**PLANNED UNIT DEVELOPMENT
STAFF REPORT****Date: April 21, 2016****DEVELOPMENT NAME**

Pastor Joe Bonner- Bey

1867 Prichard Avenue West and 100-110 Joel Court (a private street)
(South side of Prichard Avenue, 310'± West of St. Stephens Road).

Planned Unit Development Approval to allow multiple buildings on a single building site.

SITE PLAN

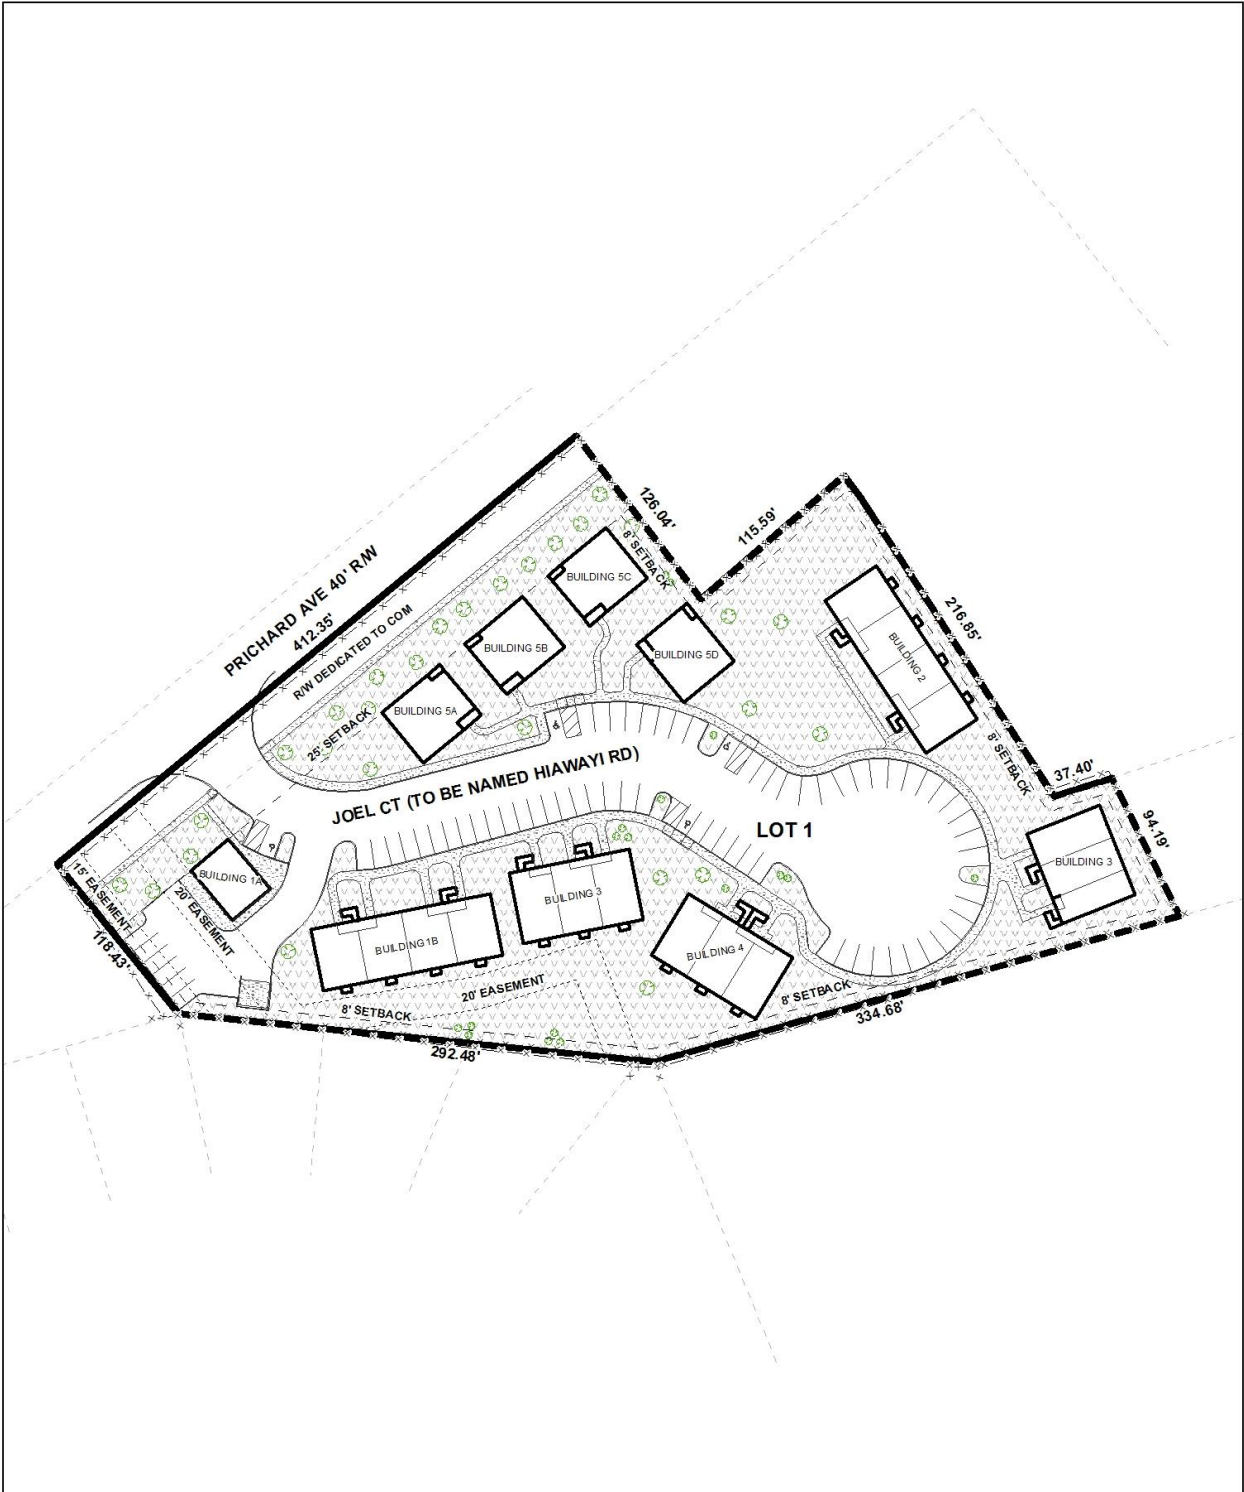
Landscaping information is provided. It appears that the overall site will comply with and exceed the minimum landscape area requirements, however, the site, as designed, will fall short of the required amount of front landscape area: 10,162 square feet of front landscape area is required, and only 9,508 square feet will be provided – a deficiency of 654 square feet. Given that 84,008 square feet of landscape area will be provided overall, well in excess of the required 16,936 square feet, the Commission may wish to consider allowing the reduced front landscape area, as proposed. It should be noted that residential PUDs require a minimum of 700 square feet of “common open space” per dwelling unit, which for this site would be at least 26,600 square feet.

Regarding tree compliance, a chart on the plan shows that 65 trees will be provided, exceeding the minimum requirement of 60 trees (per staff calculations). The site plan, however, does not reflect full tree compliance, as only 44 trees are depicted. The site plan should be revised to ensure that there are a minimum of 13 frontage trees, 22 overstory perimeter trees, and 25 understory trees, for a total of 60 trees.

A privacy fence is depicted on the site plan however the height of the fence is not indicated. While multi-family developments are not required to have a fence buffer where it abuts other uses, if a fence is provided, the height should be specified. A revised plan illustrating the height of the privacy fence will be required (not to exceed eight (8) feet). Also, if a fence is proposed along the front property line or within the front setback area, it cannot exceed three feet in height, unless a special request is included as part of the Planned Unit Development.

A dumpster pad is depicted on the site plan however it does not state if the dumpster is enclosed on all three sides or if it is connected to sanitary sewer. Any dumpster placed on the property must be in compliance with the current enclosure and sanitary sewer connection requirements of Section 64-4.D.9. of the Zoning Ordinance and must be illustrated on any revised site plan(s).

Finally, there is no indication on the site plan if a sign associated with the development will be built. If a monument or other type of freestanding identifier sign is anticipated, it should be depicted on the site plan and must comply with the signage requirements of the Zoning Ordinance.

- 2) revision of the site plan to illustrate a dumpster in compliance with Section 64-4.D.9. of the Zoning Ordinance, noting an enclosure and connection to sanitary sewer;

- 3) notation of the fence height for the depicted privacy fence (not to exceed 8 feet);
- 4) depiction of any other proposed fencing, including the proposed height;

- 5) depiction of any anticipated permanent freestanding signage, meeting Zoning Ordinance requirements for size and placement;
- 6) provision of the landscape area as proposed;

- 7) full compliance with the frontage, perimeter and parking area tree requirements of the Zoning Ordinance;
- 8) annual renewal of the PUD approval until such time as permits for the last phase of development have been issued;
